**MOUNTAIN REGIONAL WATER SPECIAL SERVICE DISTRICT  
PARK CITY, UTAH**

**SIGNAL HILL WATER TREATMENT PLANT OPTIMIZATION**

**ENGINEER PROJECT NO. 203230**

**ADDENDUM NO. 2  
TO THE  
CONTRACT DOCUMENTS**

JOB NO.  
203230  
DRAWING NO.  
40DS02  
SHEET NO.  
18 OF 296

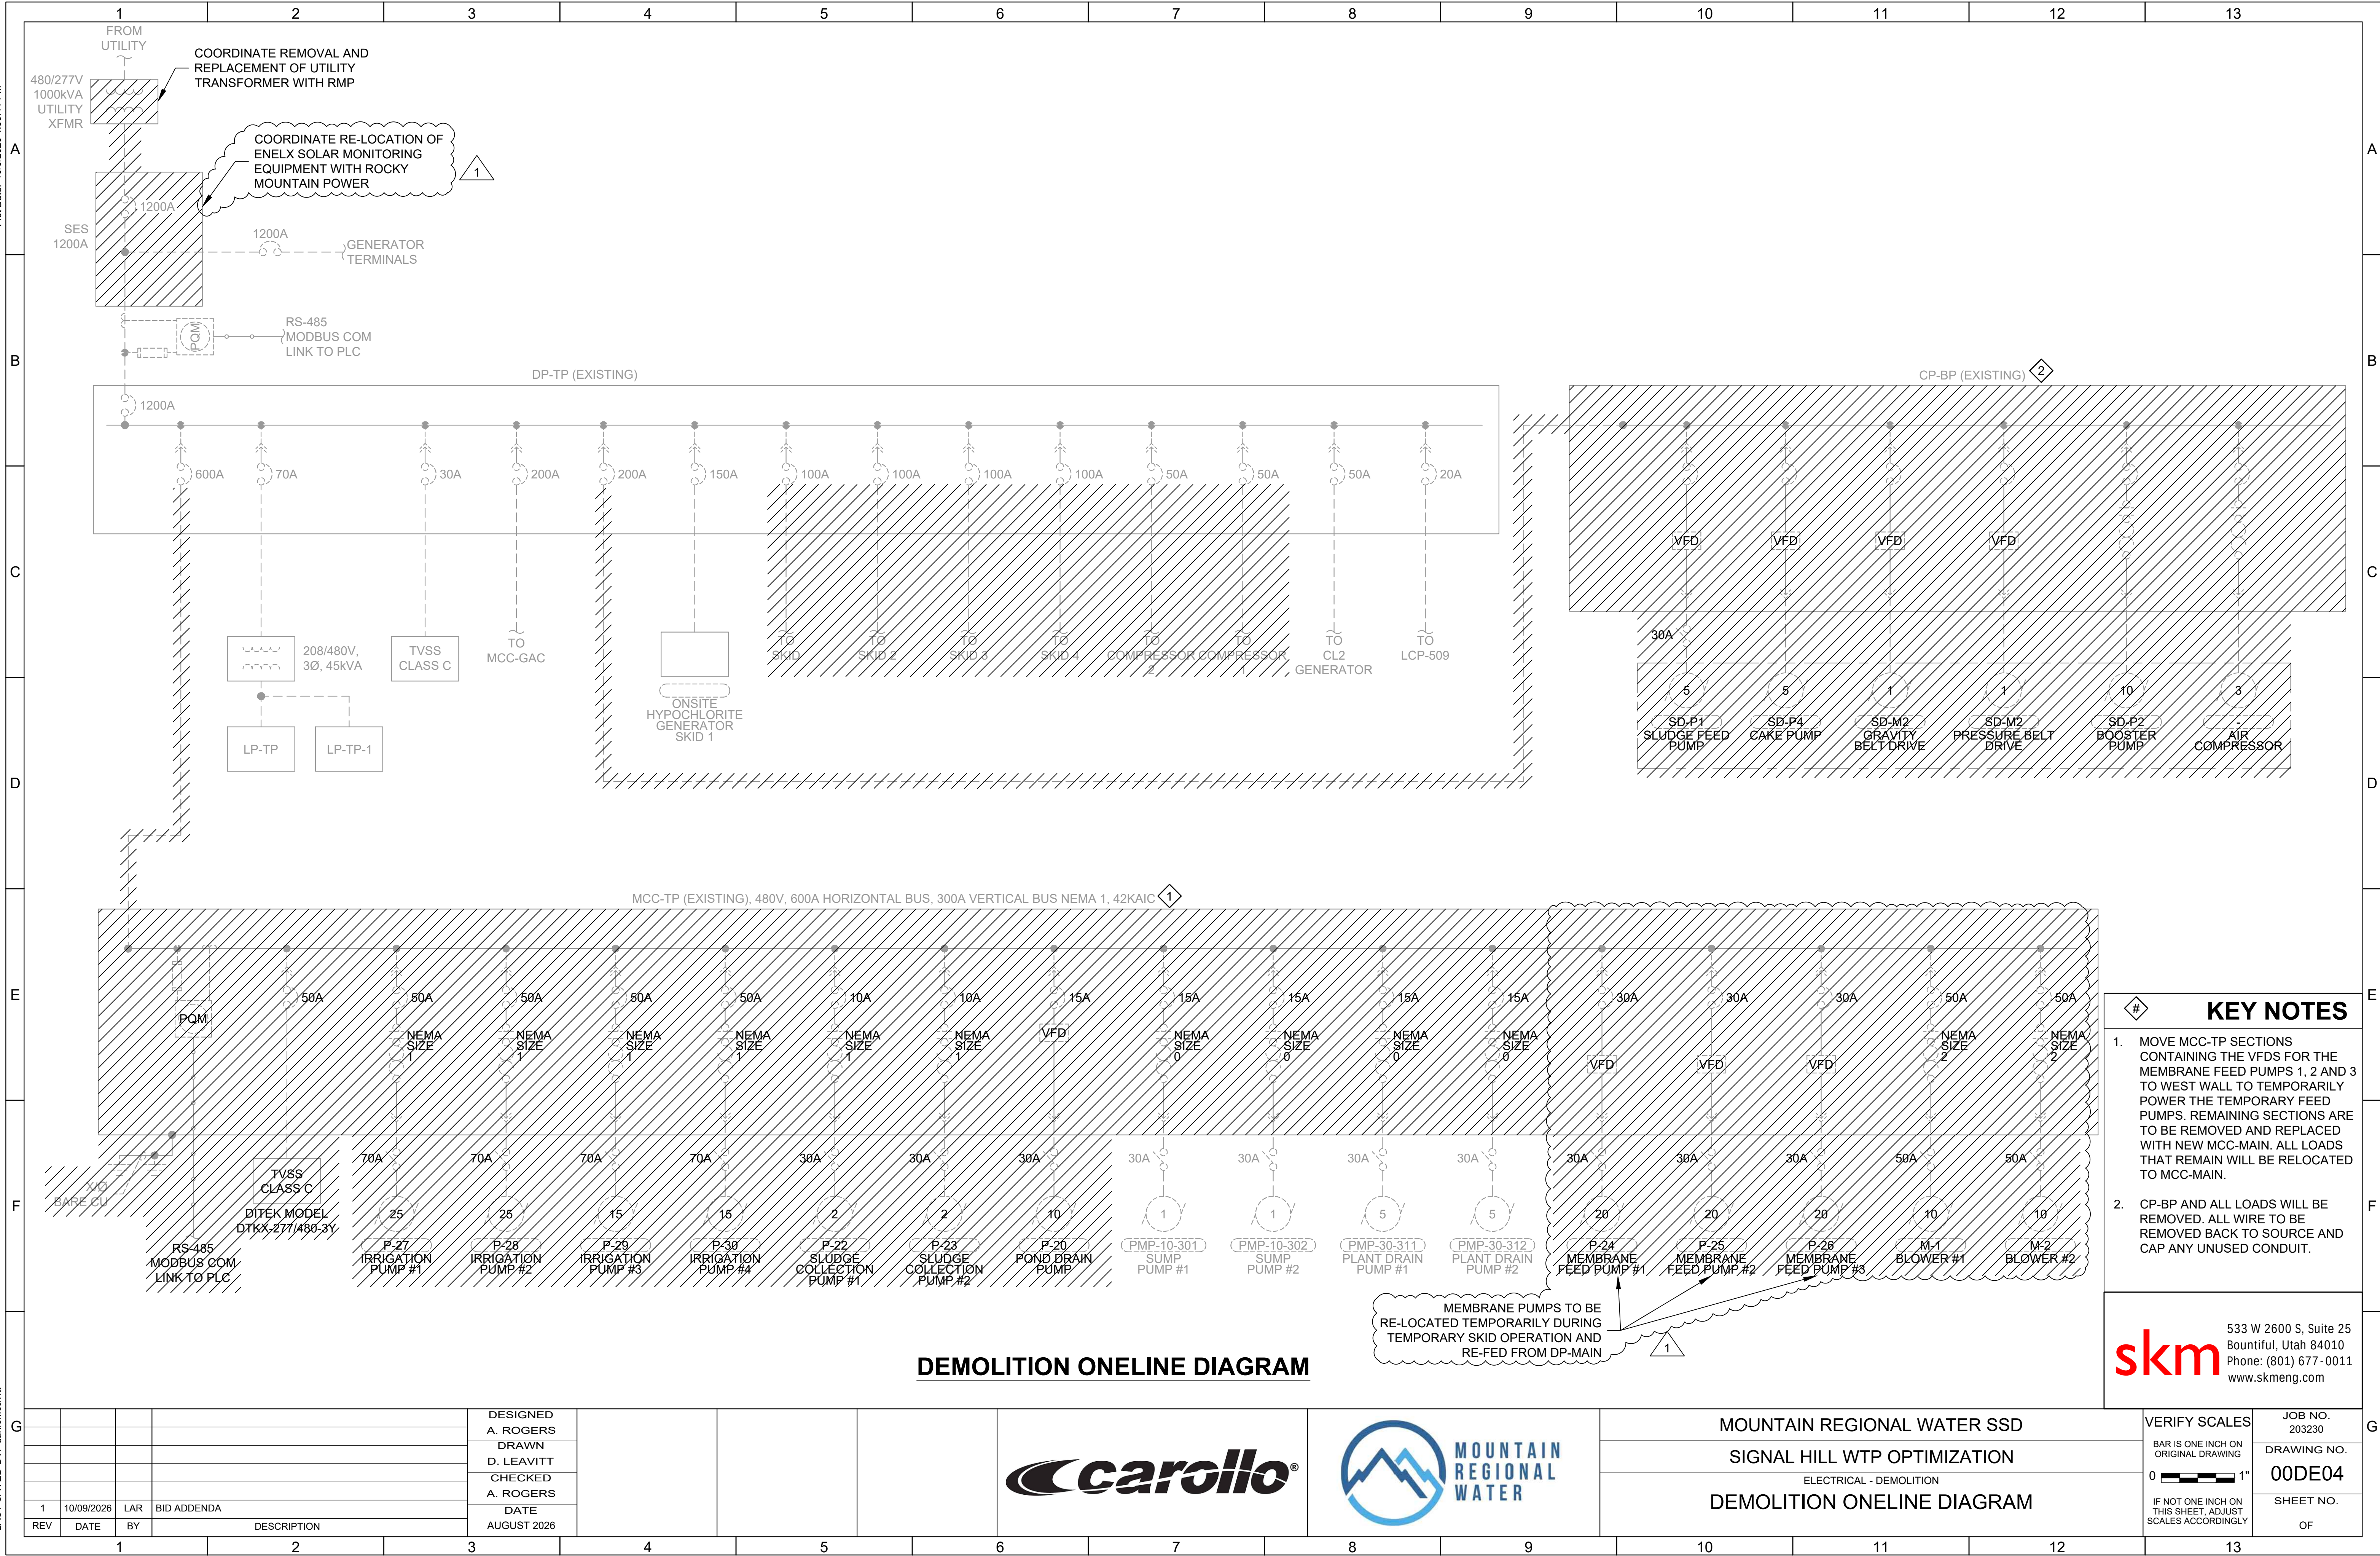
- 1. DRAWING 00G11:
  - a. REPLACE the MIN WSE in the Equalization Basin from “7031.50” with “7032.50.”
- 2. DRAWING 00G12:
  - a. REPLACE drawing in its entirety with the attached drawing.
- 3. DRAWING 00G13:
  - a. REPLACE drawing in its entirety with the attached drawing.
- 4. DRAWING 10DC01:
  - a. REPLACE drawing in its entirety with the attached drawing.
- 5. DRAWING 40DS02:
  - a. REPLACE drawing in its entirety with the attached drawing.

DRAWING NO.  
05C01

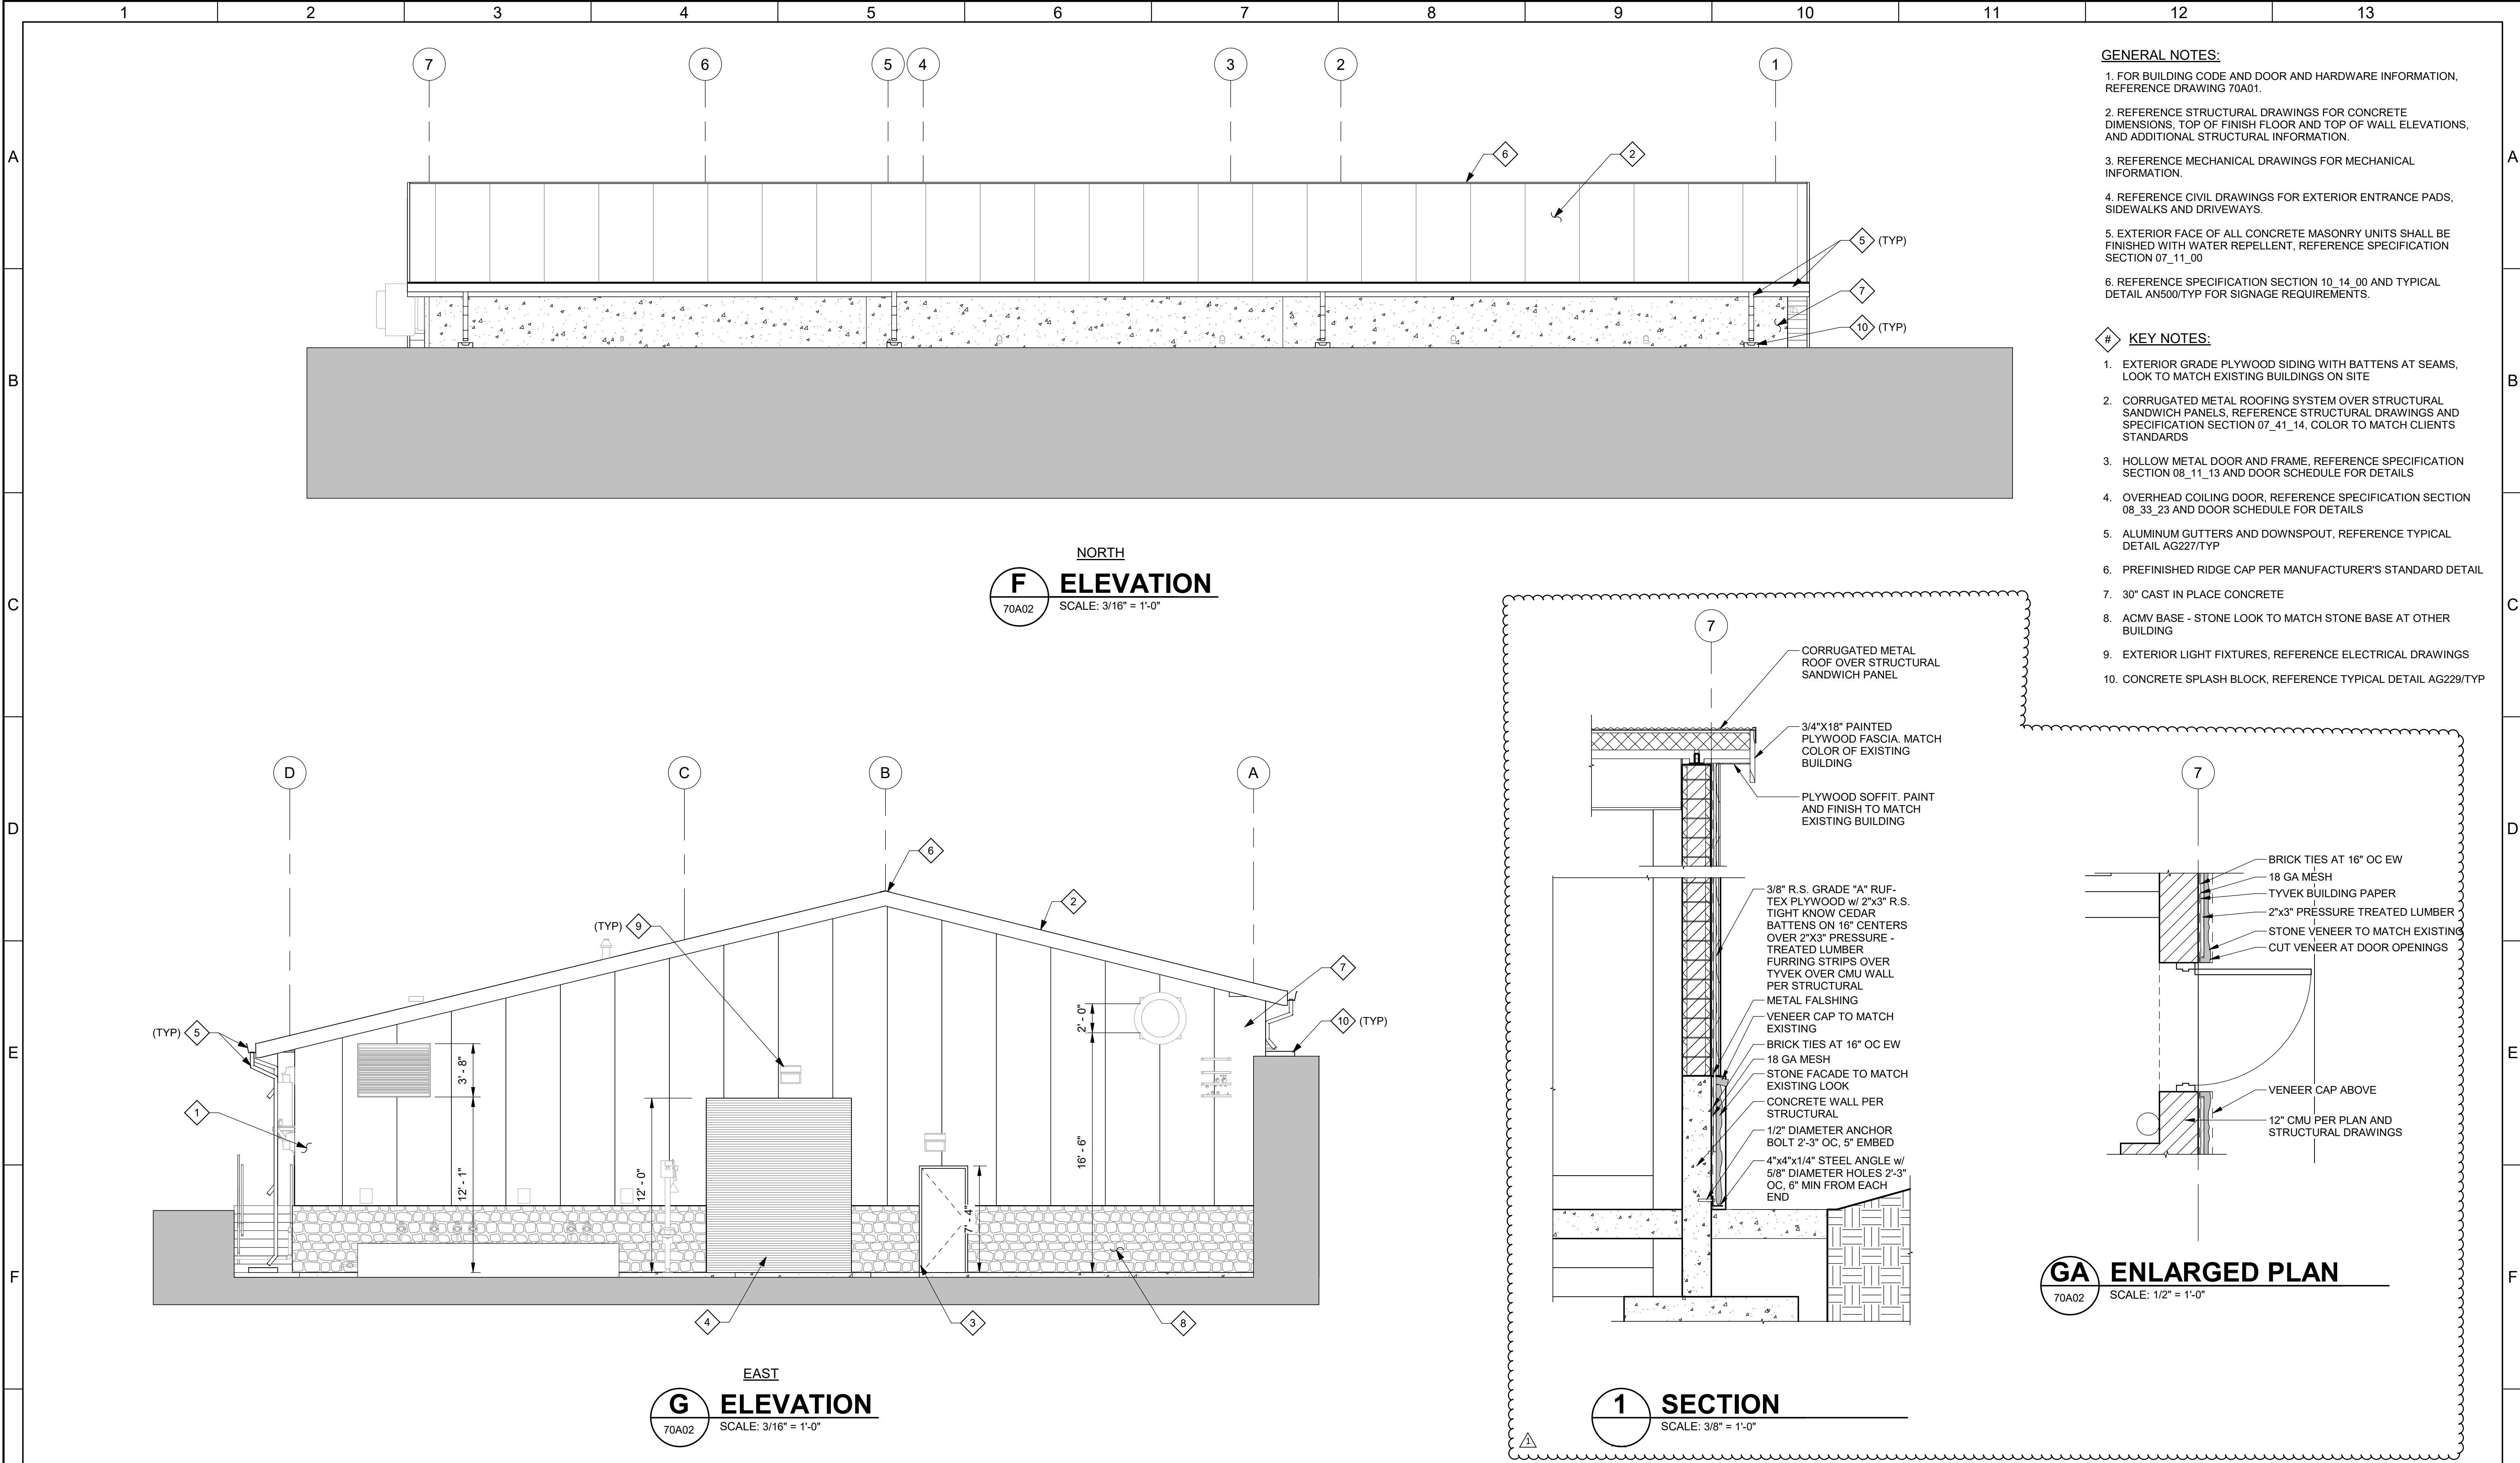
14. DRAWING 05C01:
- a. REPLACE drawing in its entirety with the attached drawing.
15. DRAWING 05C02:
- a. REPLACE drawing in its entirety with the attached drawing.

| <div><div></div><div>BIDDER QUESTION LOG</div></div>                                                                                                                                                                                                                                                                                                           |                                                                                                                                                                                                                               |
|--------------------------------------------------------------------------------------------------------------------------------------------------------------------------------------------------------------------------------------------------------------------------------------------------------------------------------------------------------------------------------------------------------------------------------------------------------------------------------------------------------------------------------|-------------------------------------------------------------------------------------------------------------------------------------------------------------------------------------------------------------------------------|
| Drawing 05C01 in key note 5 states that there are two 8” IRR pipes stacked from the treatment building to the manhole. But I’ve looked at the P&ID’s, the mechanical and demolition drawings, and the civil drawings and I’m not seeing a second line from the building to the irrigation manhole. The only two inlet lines on drawing 04C02 I see are an 8” gravity line from the 24” NPW line in the yard and the 8” pumped line from the treatment building. Please clarify the meaning of key note 5 and this second line. | Keynote 5 is not applicable and is deleted via Addendum No. 1.                                                                                                                                                                |
| Drawing 05C01 shows a 4” IRR line that appears to be coming from the treatment building, but looking at the mechanical drawings I see no connection there. Does this line wye off the 8” IRR line?                                                                                                                                                                                                                                                                                                                             | The 4" connection was on the existing 8" NPW. Landscape plan 04C03 keynote 7 calls for a new connection to the new 8" IRR and shows the 4" IRR out to the berm and irrigation to be designed by landscape contractor.         |

| <div><div><div><div>carollo®</div></div></div><div>BIDDER QUESTION LOG</div></div>                                                                                                                                                                                                                                                                                                                                                                            |                                                                                                                                                                                                                                                                                                      |
|-----------------------------------------------------------------------------------------------------------------------------------------------------------------------------------------------------------------------------------------------------------------------------------------------------------------------------------------------------------------------------------------------------------------------------------------------------------------------------------------------------------------------------------------------|------------------------------------------------------------------------------------------------------------------------------------------------------------------------------------------------------------------------------------------------------------------------------------------------------|
| Sheet 05C01 shows a 4” IRR line running from the northwest side of the process building. Please provide information on this line.                                                                                                                                                                                                                                                                                                                                                                                                             | See landscape drawing 04C03 for origination and tie in of 4" IRR to provide irrigaiton water to berm planting area.                                                                                                                                                                                  |
